Queensland Rail
Northern Missing Link

Coordinator-General's Report

October 2006

Plan of Suttor Road crossing

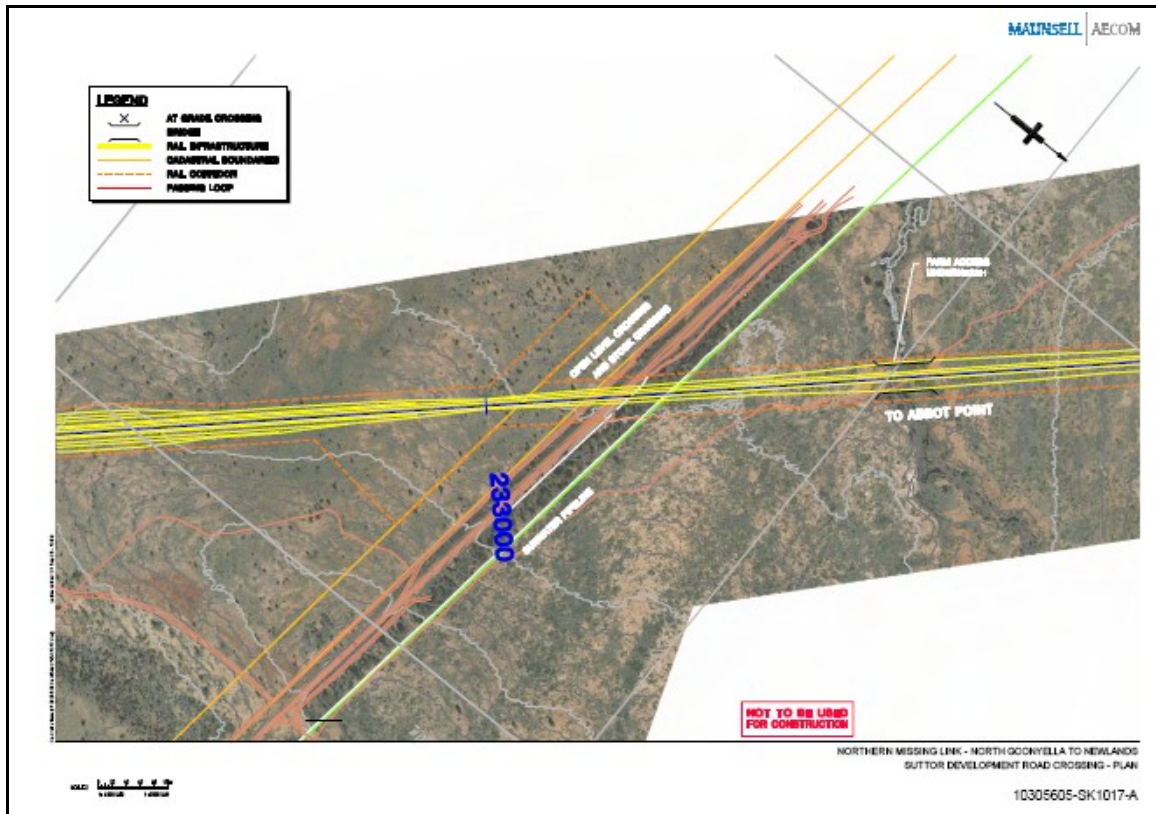
QT, DMR, and the Nebo Shire Council each requested that QR reconsider the proposal for an 'at grade' rail crossing at the intersection with the Suttor Developmental Road, and replace it with a grade separated crossing (road over rail bridge). They raised questions of safety for an east/west aligned road, impact of new rail crossings on existing road users, and inconsistency of treatment between the Suttor and the proposed Cerito Road/rail crossing north-west of Glenden.

The Suttor Road at the crossing point is a straight road running east west, having a well graded non-bitumen surface. The current road traffic count is approximately 60 vehicles per day. The rail line crosses open country either side of the road, and there is ample visibility of the crossing along both rail and road directions. The following photographs show the existing road situation from both directions, together with a view of the rail corridor alignment to the south of the road. A plan view of the proposed intersection is also presented.

- An ALCAM safety assessment score of 107 allowing for protection by lights and signals on the Suttor Development Road/NML crossing is satisfactorily below the ALCAM standard of 200 for a road traffic count of 100 vehicles per day and maximum train count of 29 per day. (See Appendix 2 for the detail of the ALCAM model results for various scenarios for the Suttor Road crossing).

Prior to commencement of rail operations, QR shall provide level crossing facilities with levels of protection including at least the following elements:

- a. flashing lights with back boards to reduce the impact of sunlight glare to oncoming vehicles;**
- b. additional road warning signs ahead of the crossing indicating road/rail crossing to be erected in accordance with the Manual of Uniform Traffic Control Devices;**
- c. a minimum 8 metre wide two lane bitumen road constructed for a minimum of 250 metres either side of the road/rail crossing; and**
- d. road approaches designed in accordance with DMR – Road Planning and Design Manual and constructed in accordance with DMR Standard Drawings and Specifications.**
